United States Patent and Trademark Office

| APPLICATION NO. | FILING DATE | FIRST NAMED INVENTOR | ATTORNEY DOCKET NO. | CONFIRMATION NO. |
|---|-------------|----------------------|-------------------------|------------------|
| 10/693,064 | 10/23/2003 | Phillip W. Barth | 10021090-1 | 2224 |

Advisory Action

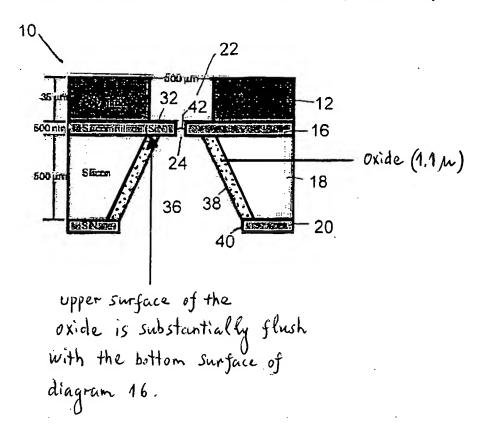
1. In the Response filed 12/16/05, applicant argues that "the upper surface of an oxide layer formed on the sidewall 38 of recess 36 as described in Bloom is substantially flush with substrate region 18 and **not substantially flush with the first region**16."

The Examiner respectfully disagrees. Figure 1A of Bloom is reproduced with an oxide layer of 1.1 microns thick formed on the sidewalls 38 when the exposed semiconductor substrate is oxidized (col. 9, lines 23-26; col. 10, lines 52-55).

As shown in the above figure, the upper horizontal surface of the oxide layer is substantially flush with the bottom surface of the first region (the diagram 16).

As noted in the previous Office action, since the walls 38 of the silicon substrate

region 18 surrounding the first region comprising diagram 16, the aforementioned oxide layer formed on the sidewalls are also surrounding the first region. Therefore, the aforementioned oxide layer reads on the claimed second region surrounding the first region and having an upper surface substantially flush with the bottom surface of the first region.
